Transport
for NSW

M5 Motorway Westbound Traffic Upgrade

Submissions Report

March 2024

Figure 2-2 Predicted operational noise levels for the ground floor along Secombe Place

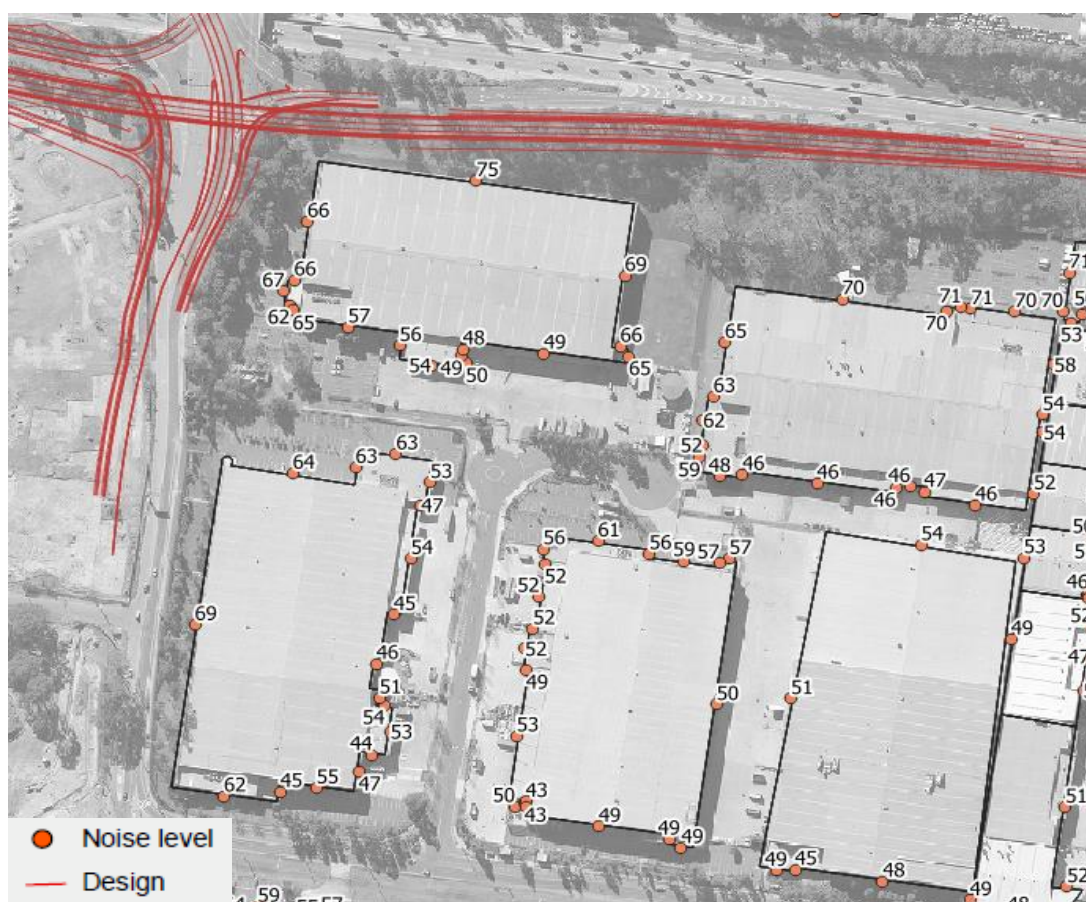
- Requests detailed operational noise impacts for 2-8 Secombe Place, including Amtek's facility. The proposal will involve bringing the road corridor much closer to Amtek's facility as well as remove existing sound barriers (including the earth mound and trees). The building that Amtek occupies is not designed to mitigate noise; the building façade has large open vents, which do not provide adequate noise attenuation.

A *Noise and Vibration Impact Assessment* was prepared for the proposal. This assessment considered the proposal design documented in the REF, including the effect that the proposed new traffic arrangements (such as the longer Hume Highway exit ramp) would have on operational traffic noise levels (now and into future). The assessment identified that the proposal would not substantially change existing road traffic noise levels in the study area, including at the Amtek's facilities, with a change of within one decibel expected for most residential properties. A change of 1 or 2 decibels in noise is generally difficult for most people to perceive. Notwithstanding, 81 residential properties would exceed the triggers for consideration of mitigation due to high existing road traffic noise levels. In accordance with the *Road Noise Mitigation Guideline* (Transport 2022), all 81 residential properties would be considered for additional noise mitigation.

Vegetation is not considered to provide effective noise mitigation or noise attenuation, and the removal of vegetation required for the proposal is not a contributor to predicted noise impacts associated with the proposal. Although vegetation may provide a visual screening, as it is not a solid obstruction, the amount of vegetation currently in place does not minimise noise impacts. The impacts to the properties in Moorebank Logistics Park have been considered and modelled in the *Noise and Vibration Impact Assessment*. The noise mitigation strategy prepared for the proposal would be used to determine the appropriate noise mitigation measures for impacted properties.

criteria for noise sensitive receivers and land uses in Table 3 and Table 4. The Road Noise Policy does not classify commercial or industrial premises as noise sensitive and there are no mandatory operational criteria. The proposal is not predicted to substantially alter operational road traffic noise levels. The properties at Secombe Place are predicted to have a change of less than 1 dB increase, with Figure 2-2 showing predicted operational noise levels for the ground floor. A change of one or two decibels in noise is generally difficult for most people to perceive. Transport will continue to consult with impacted receivers and monitor the noise levels as required. Additionally, the increase in operational road traffic noise following the opening of Moorebank Logistics Park is expected to be minimal. Current construction traffic in the area currently uses the existing busy roads such as the M5 Motorway and Moorebank Avenue and due to the high existing volumes of traffic on these major roads operational noise would be generally difficult to perceive.

Figure 2-3 Revised cyclist route westbound on the M5 Motorway

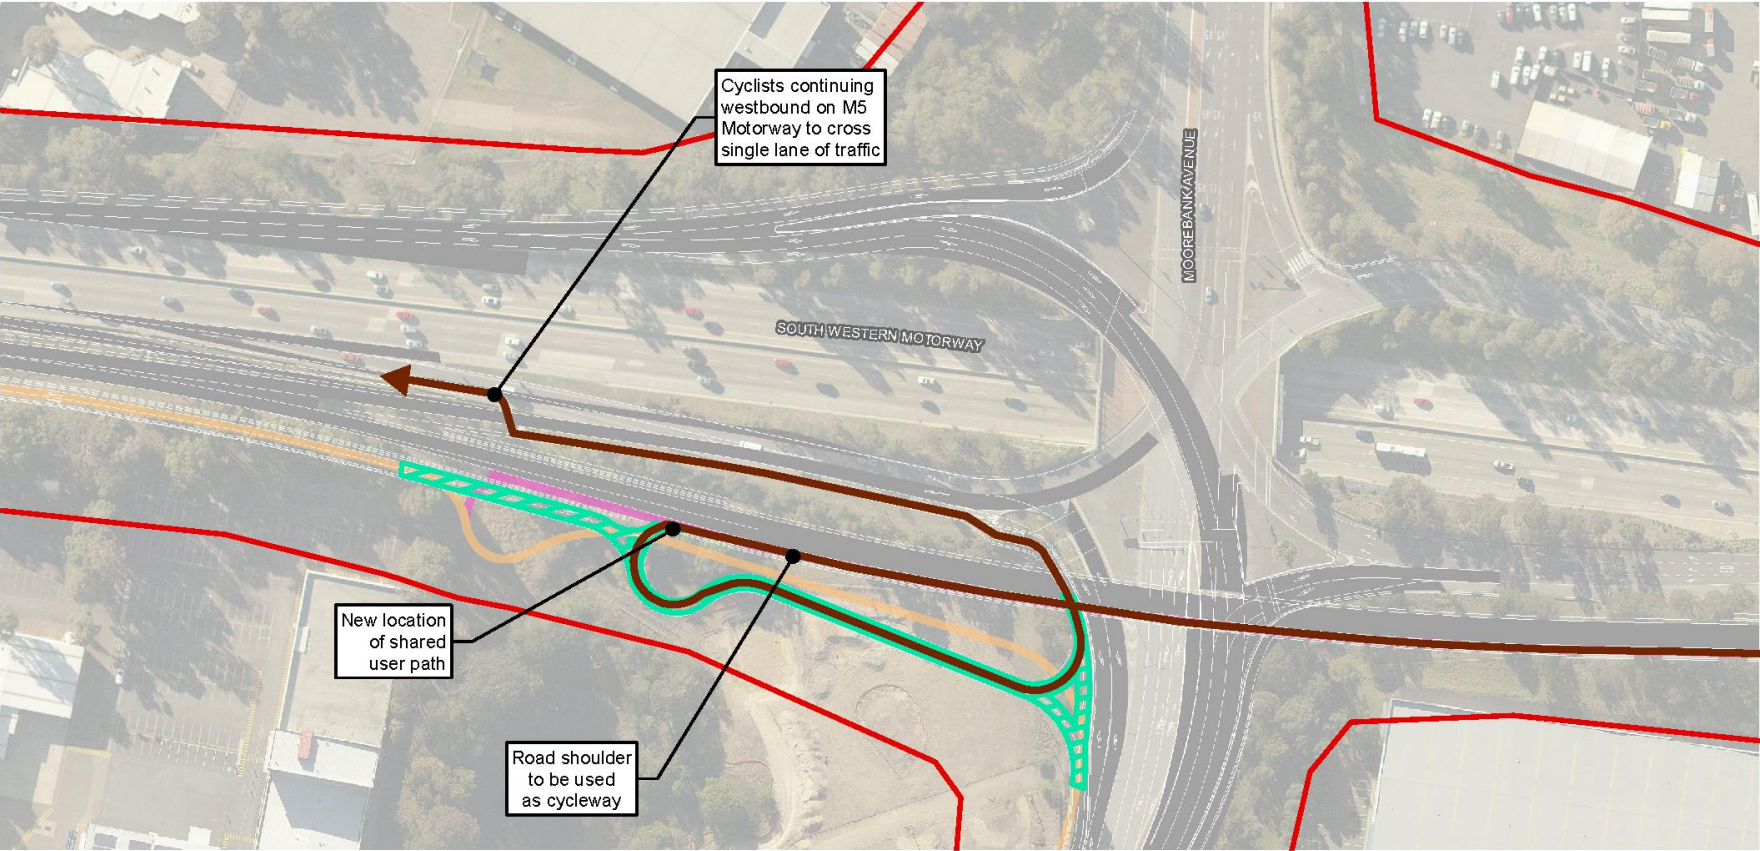
- Concerned about the movement of construction vehicles across pedestrian and cycling paths. The REF did not contain detailed traffic management plans and, therefore, it is difficult to assess the impact of the proposal on active transport.

The proposal design has been further refined following public display of the REF to further improve cyclist safety conditions and reduce confusion (relative to the design presented in the REF). The proposal design now also includes provisions for the shared path to be connected to future extensions of Council's active transport network. These design refinements are described further in Section 4 of this report. Investment in this proposal does not preclude works to other parts of the transport network including public transport.

After the underpass of Moorebank Avenue, there would be an entry to the shared user path for cyclists wanting to use the path to travel westbound or onto Moorebank Avenue. Cyclists can enter onto the shared user pathway to travel westbound on the new bridge to Casula. Cyclists wanting to continue travelling westbound on the M5 Motorway would need to take the same entry onto the shared user path as those travelling towards the Hume Highway exit. At this point they would then be required to return back east to continue to the Moorebank Avenue/ M5 Motorway intersection. Upon re-entering the Motorway via the westbound entry ramp cyclists would be required to cross a single lane of traffic to then re-join the M5 Motorway via the existing entry ramp. Refer to Figure 2-3 for an illustration of this movement.

There would be signage for cyclists travelling westbound on the M5 Motorway within the road shoulder, between the Heathcote Road exit and Moorebank Avenue, to direct them to continue onto the new exit ramp toward the Hume Highway. There would also be signage after the new underpass to direct cyclists wanting to continue westbound on the M5 Motorway. These cyclists would need to travel to the M5 Motorway / Moorebank Avenue intersection and re-join the M5 Motorway via the existing entry ramp.
